CUMBERLAND
CITY COUNCIL

OA2024/0007

Subject: Request for comments – Proposed Cumberland Golf Club Seniors Housing Development - SSD
Application No: OA2024/0007
Property: 246-248 Old Prospect Road Greystanes
Proposal: Ministerial Consent - Proposed Cumberland Golf Club Seniors Housing Development - Advice on EIS - SSDA-64795219

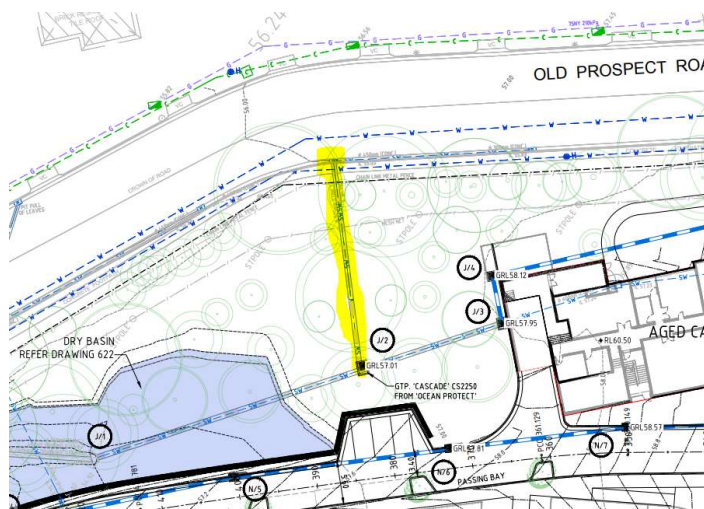
- a) Site survey plan shall be submitted. Survey shall refer to Australian Height Datum (AHD).
- b) The proposed modifications to the dam basins (eastern and western) are not acceptable as it increases the outflow from the development site.
- c) The peak flow comparison table 8 of the Stormwater and Flood Management Report conflicts with the table 9.
- d) The table 9 shows that proposed outflow exceeds the pre-development outflow. Stormwater runoff from the eastern and western dams to Council system shall not be increased.

- e) Street drainage connection details conflicts with the Council's mapping details. In this regard, stormwater plan shall verify the connection between the street stormwater pit and pit J/2 within the site.
